Date: November 1, 2022

Subject: ADDENDUM #3

Project: Transition Building
(T99) Addition

Project No: 220081

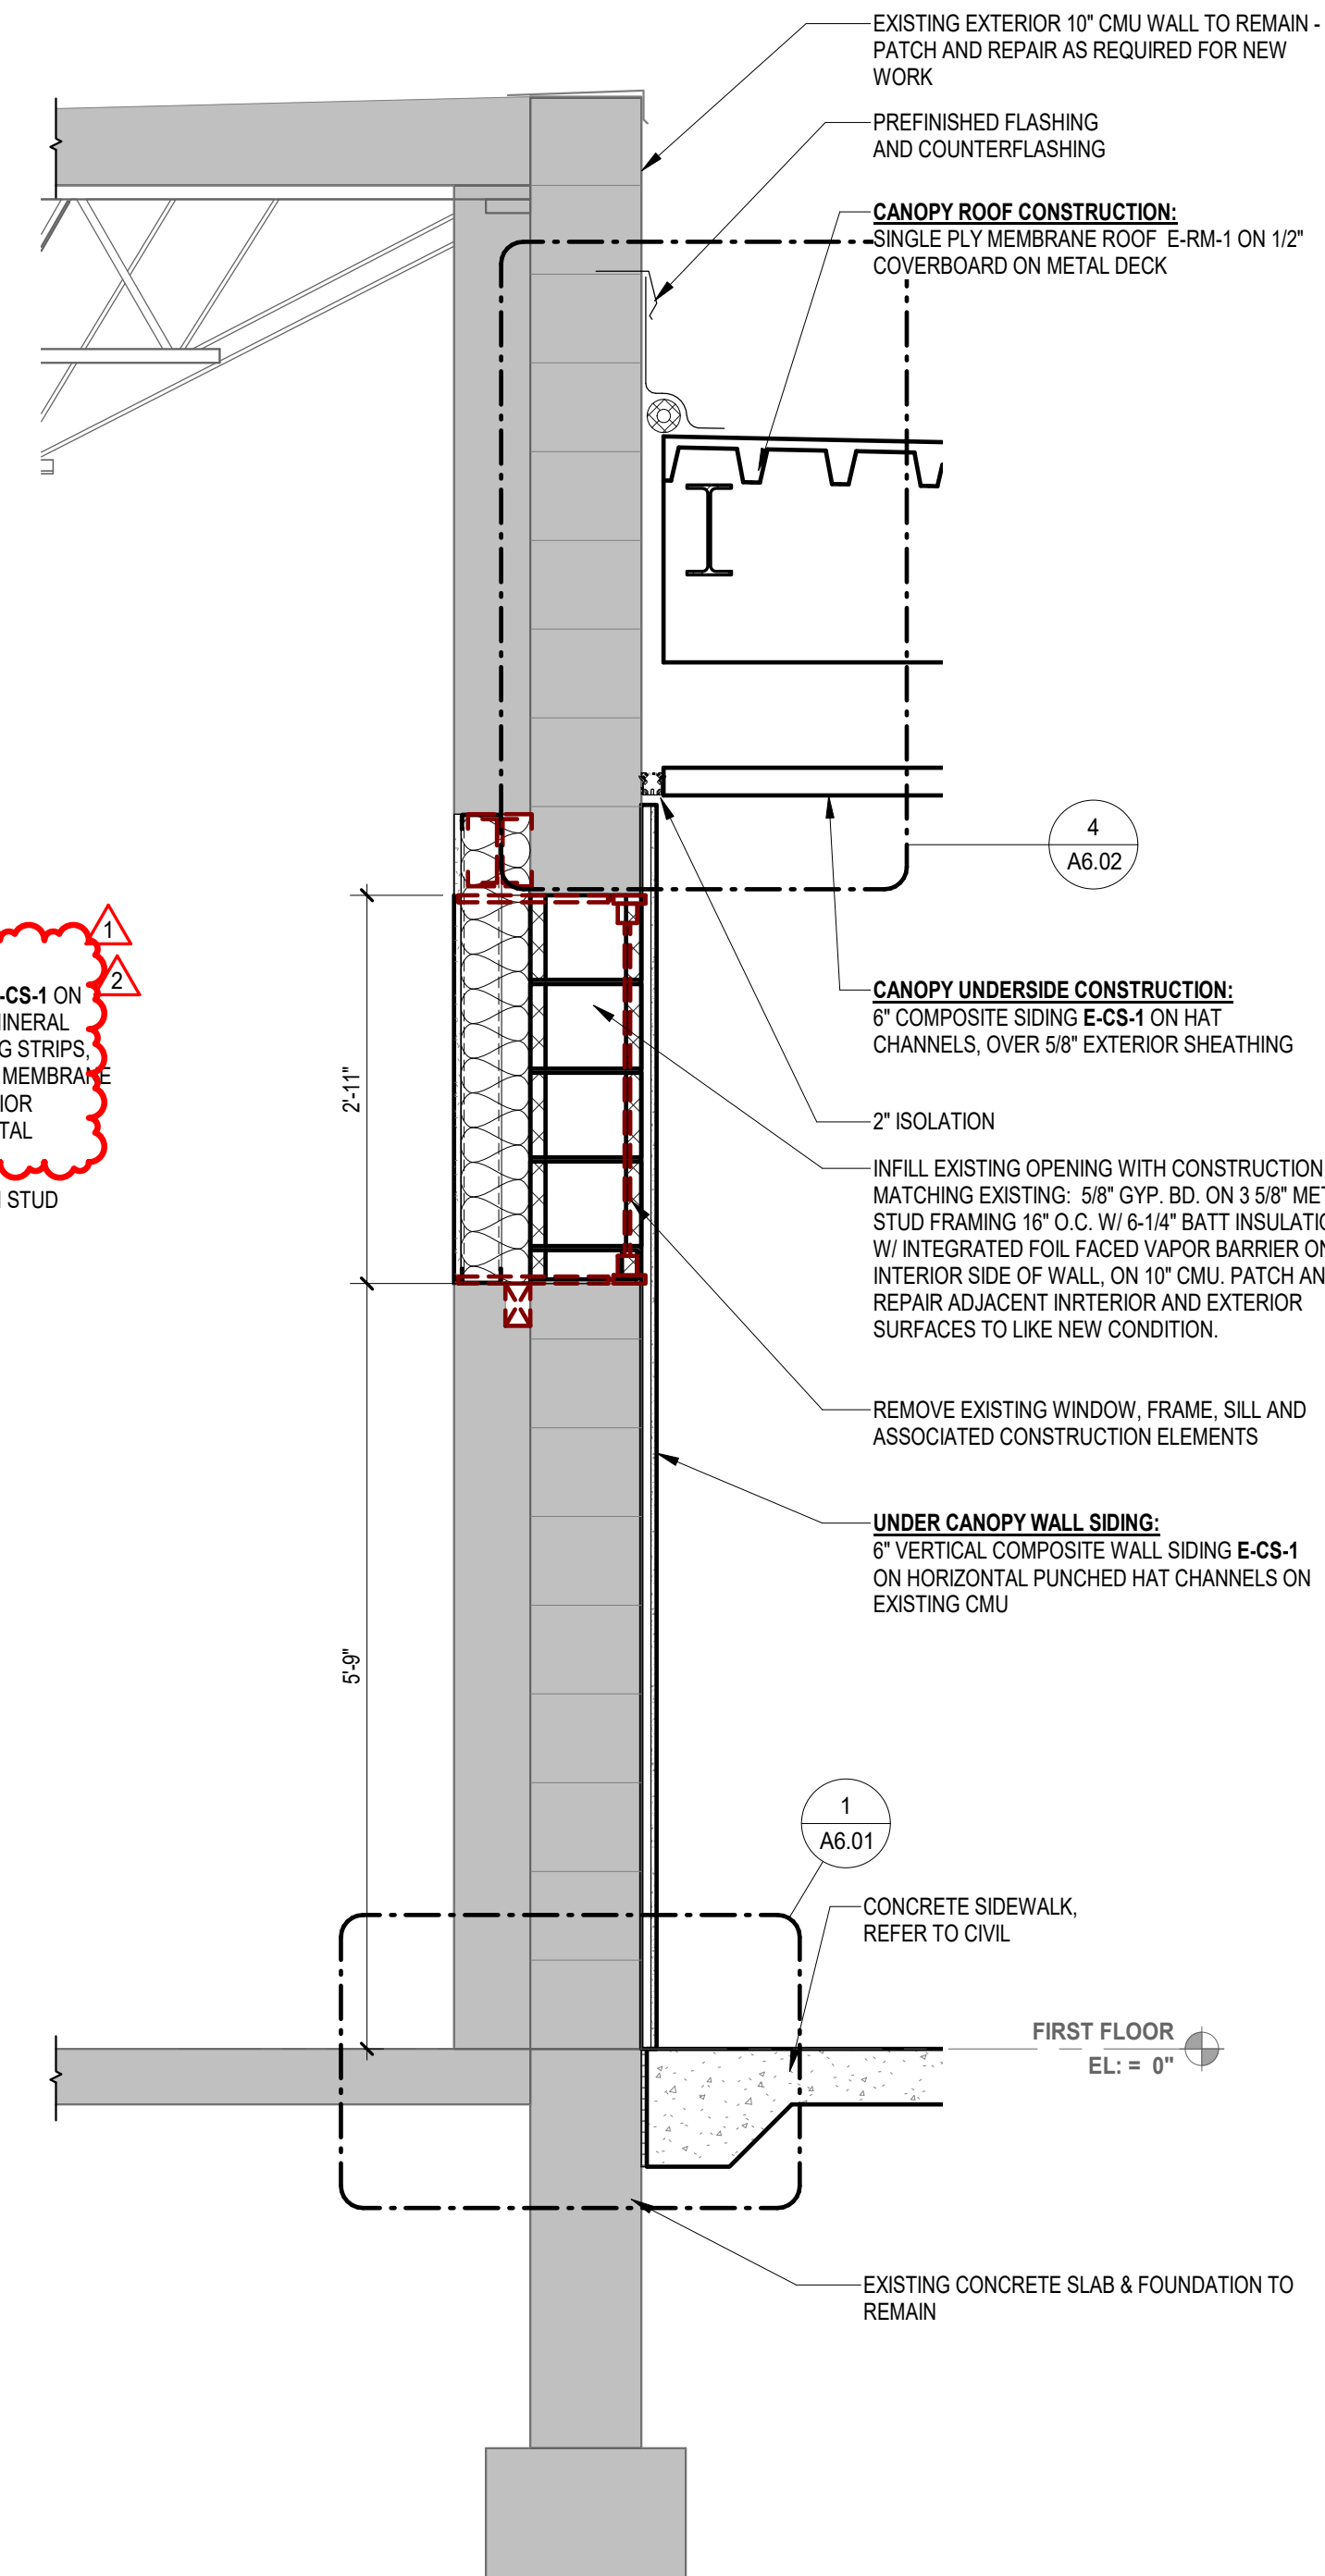
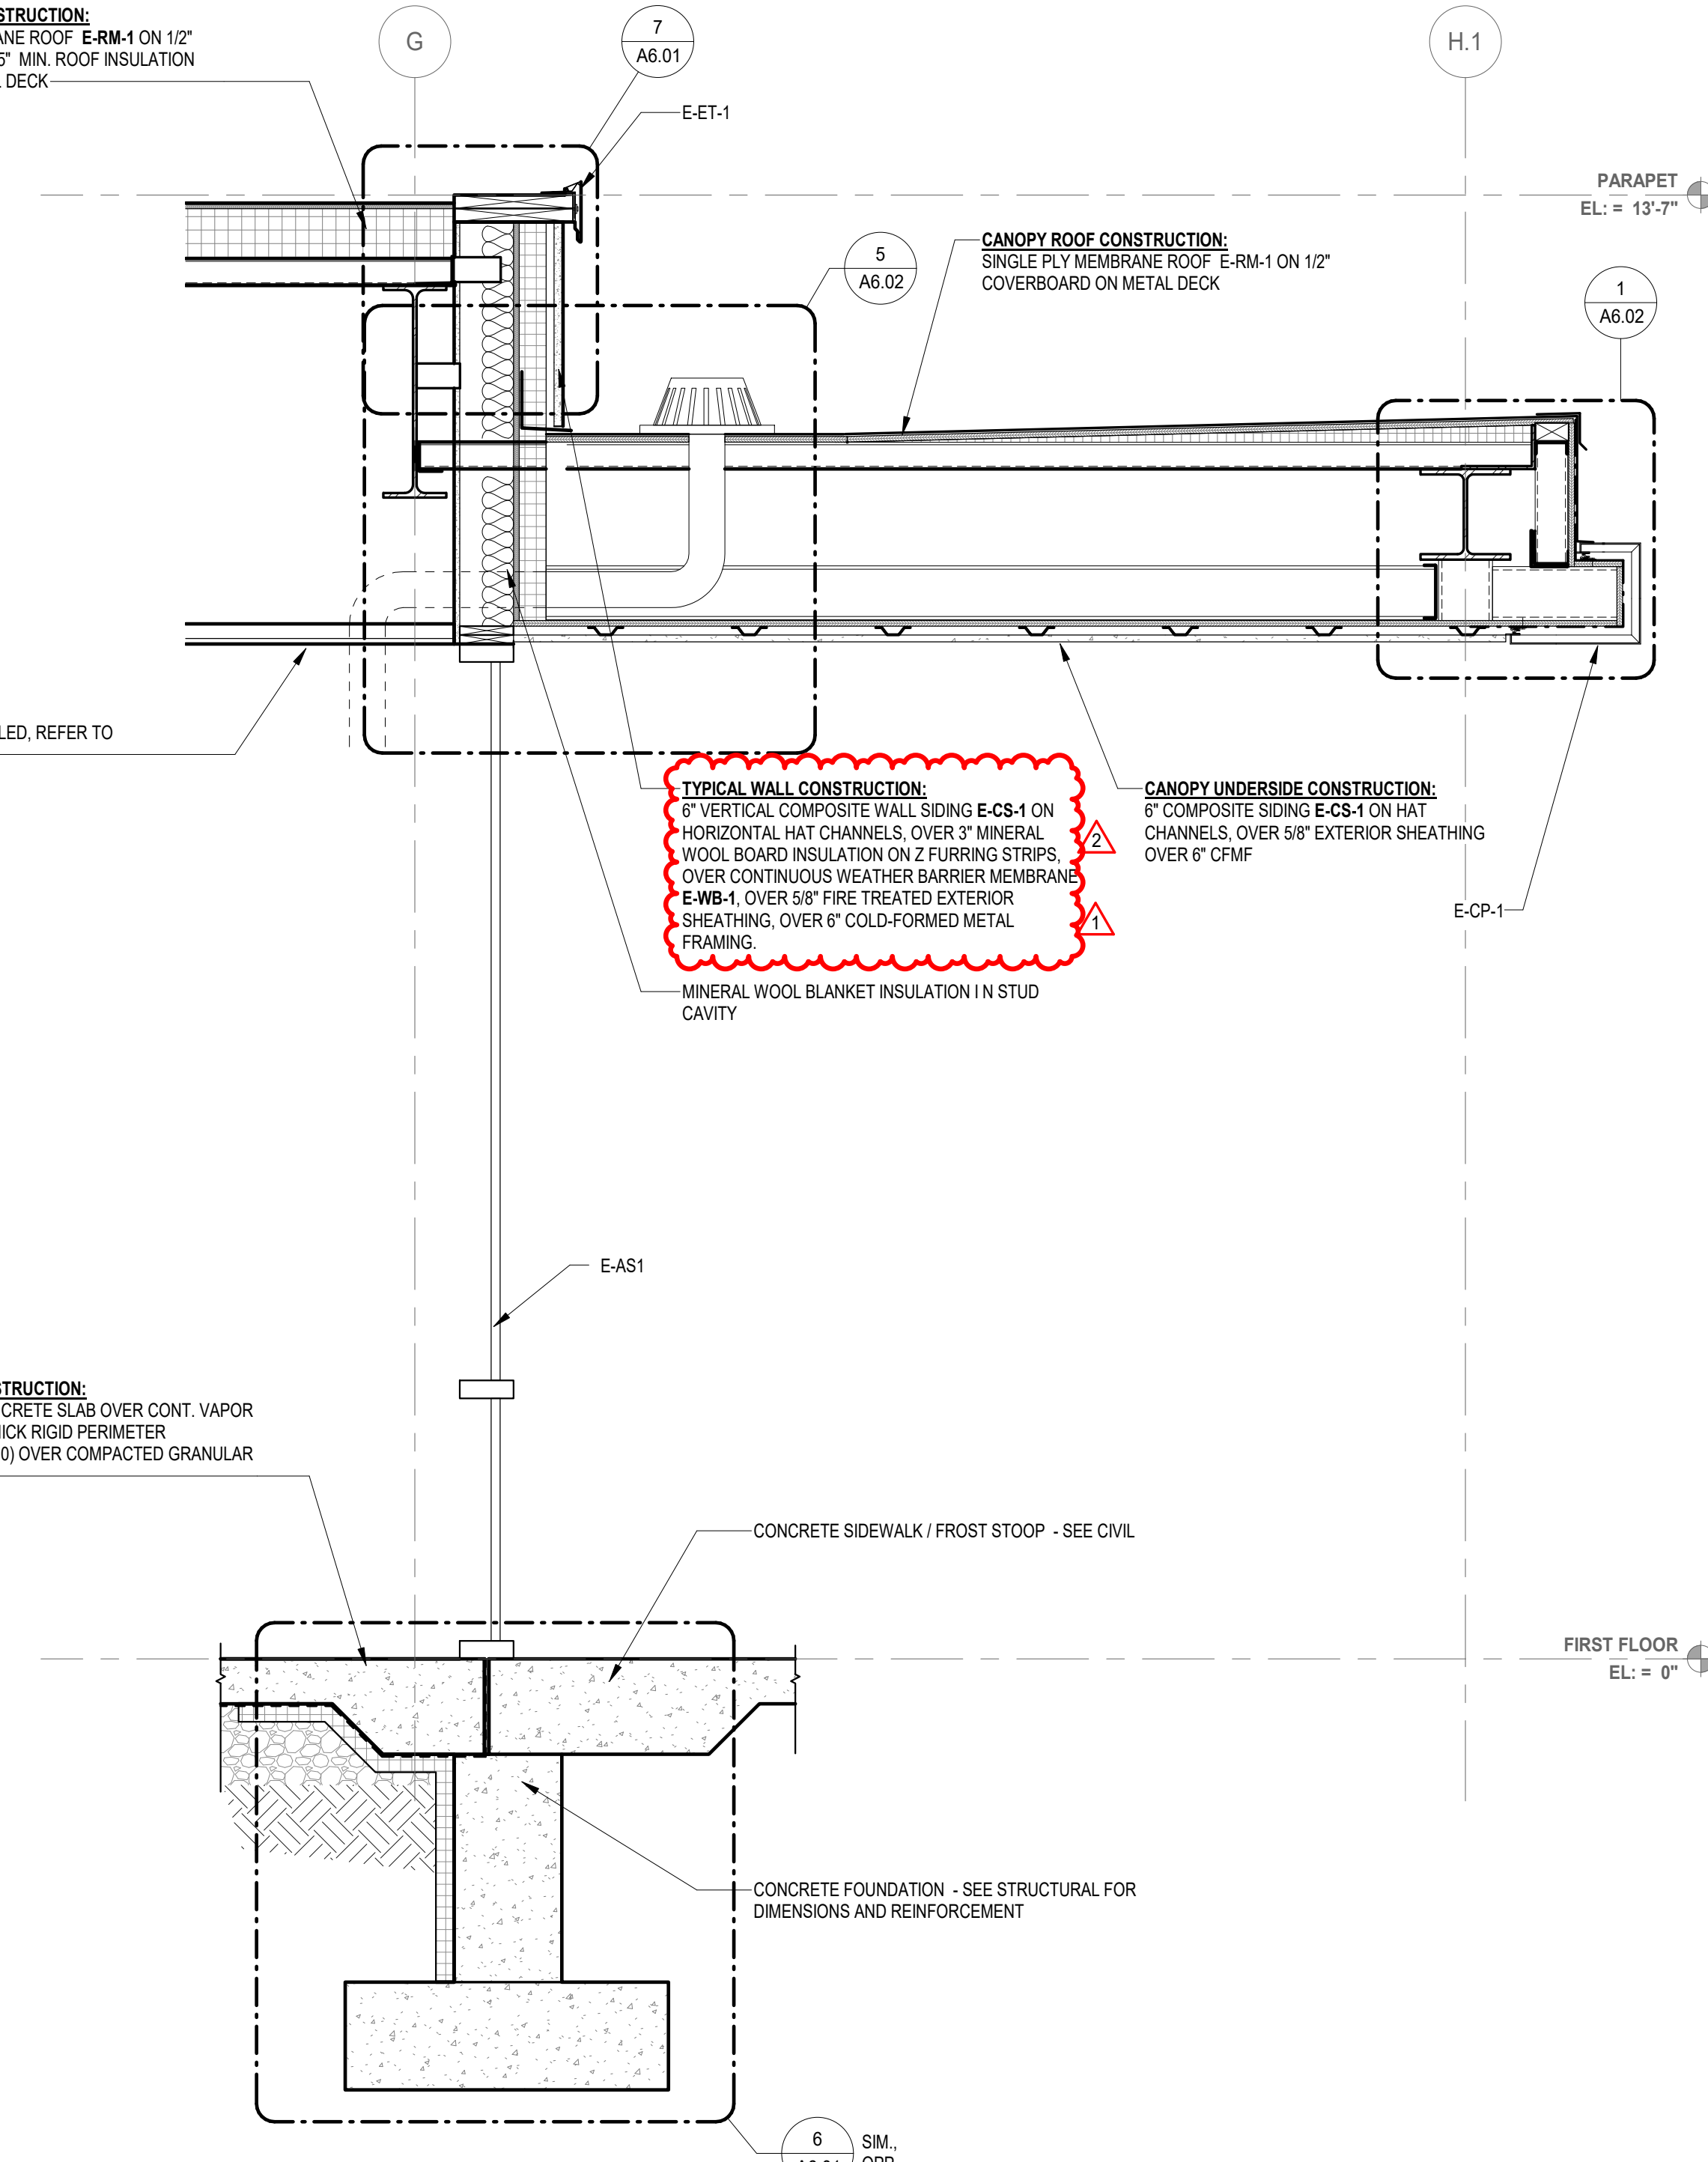
1. ***SHEET A5.00*** (FULL SIZE SHEET REISSUED)
 - Revised "horizontal punched hat channels" to "horizontal hat channels".
2. ***SHEET A5.01*** (FULL SIZE SHEET REISSUED)
 - Revised "horizontal punched hat channels" to "horizontal hat channels".
3. ***SHEET A6.01*** (FULL SIZE SHEET REISSUED)
 - Revised "horizontal punched hat channels" to "horizontal hat channels".
4. ***SHEET A6.02*** (FULL SIZE SHEET REISSUED)
 - Revised "horizontal punched hat channels" to "horizontal hat channels".
